Power Supply Test Result Comparisons

For AeroBar® - Model 5685U

Product	AeroBar Model 91-5685U-44
Test Result Comparisons:	120V: New Power Supply – P/N 33-1420-01 Old Power Supply – P/N 14-21527, 14-1523 (no longer available)

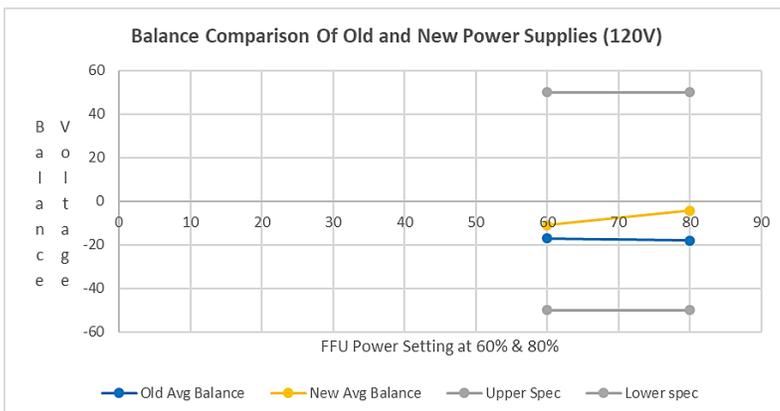
In supporting the performance of our new power supply for the AeroBar Model 5685U (Model 91-5685U-44), below are the test results comparing the performance of the new and old power supply (which is no longer available) in both 120V & 240V.

With the new power supply, the results are a little better (see results below) than with the old version, but we've published that the results are identical.

The specification is 25 secs or less. The test was run 25 times. (120V)

The balance specification is +50V to -50V
